VICKERY COAL MINE PROJECT

Submission of the Wando Conservation and
Cultural Centre Inc, Maules Creek

VICKERY COAL MINE SSD7480
Groundwater Assessment FIGURE 62

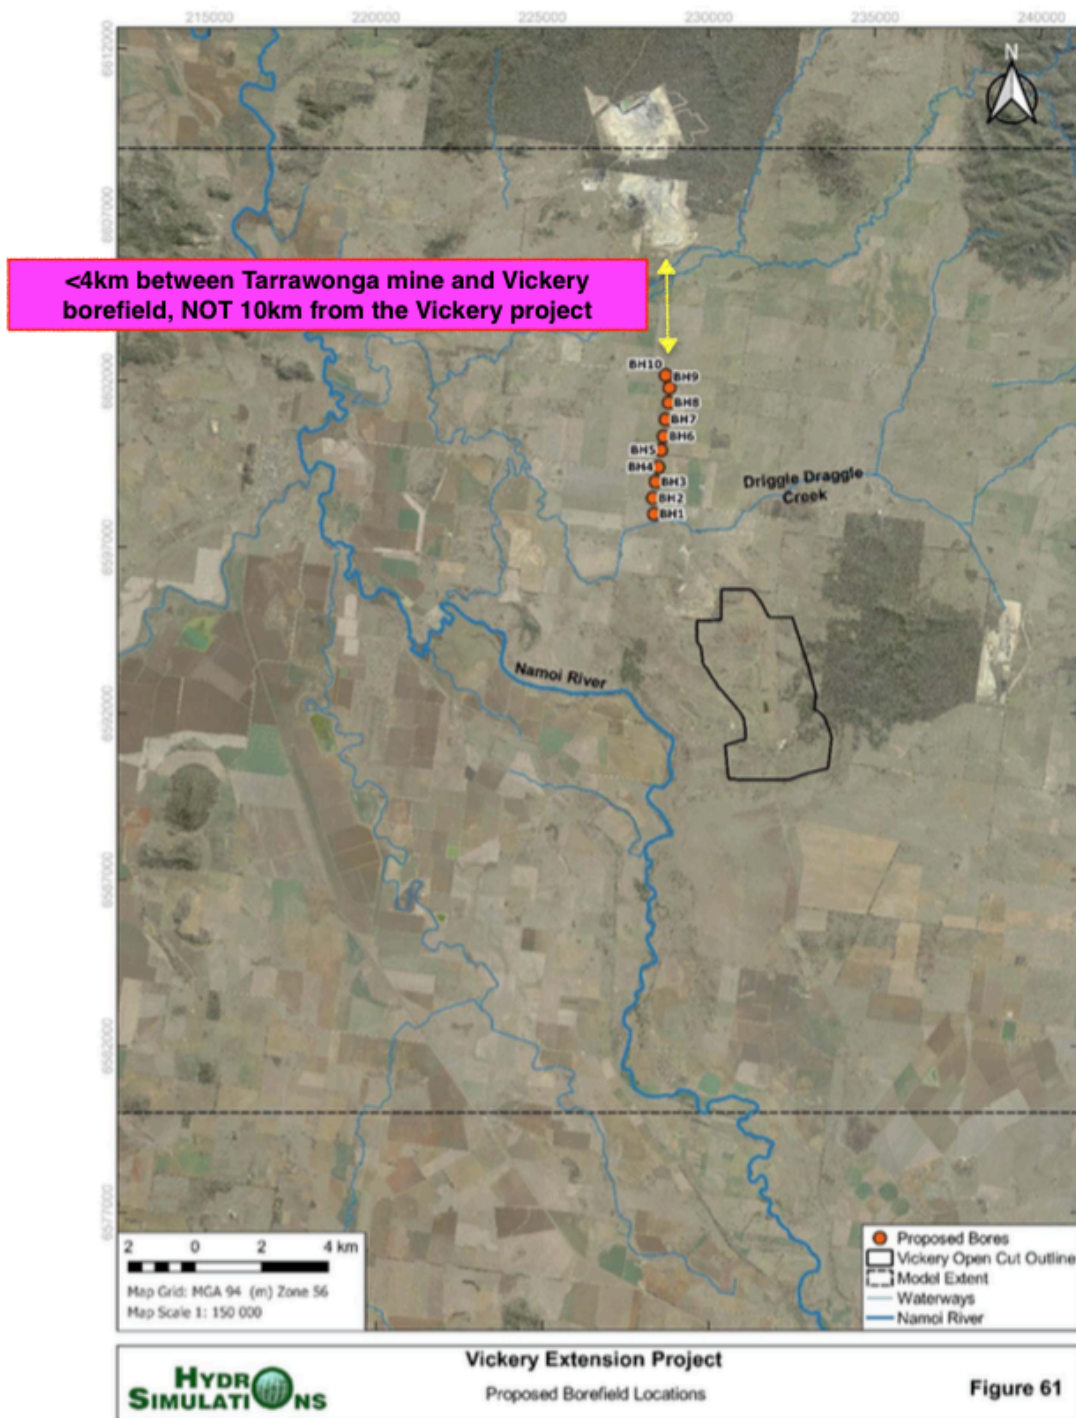
The new borefield brings the footprint of the Vickery project within 4km of the Tarrawonga Mine, contrary to what the Groundwater Assessment itself states. We do not believe that the cumulative impacts have been adequately assessed.

The potential cumulative impacts of four coal mines extracting a total of 35 MTPA within the relatively small region, and three Coal Handling and Processing Plants washing this quantity of coal, is being approached very lightly by the Vickery Extension EIS and Groundwater Assessment.

Maules Creek has current approval for 13MTPA but proposing to expand another 4 MTPA towards the North Exploration Licence A346 (with a stated determination to mine the EPBC-mandated East-West Biodiversity Corridor approximately 4 MTPA), Boggabri Coal (currently 8MTPA, and now also considering mining the EPBC-Biodiversity Corridor), Tarrawonga (4MTPA) and Vickery (10MTPA now, and further 4 MTPA in the Vickery State Forest).

In addition, there are numerous other Exploration Titles to the East of the Leard State Forest (Goonbri), North and in between Vickery and the Leard mines.

This massive mining region should be considered holistically, not in a piecemeal and fragmented manner.

This should be done before any further consideration is given to the Vickery Extension Project.
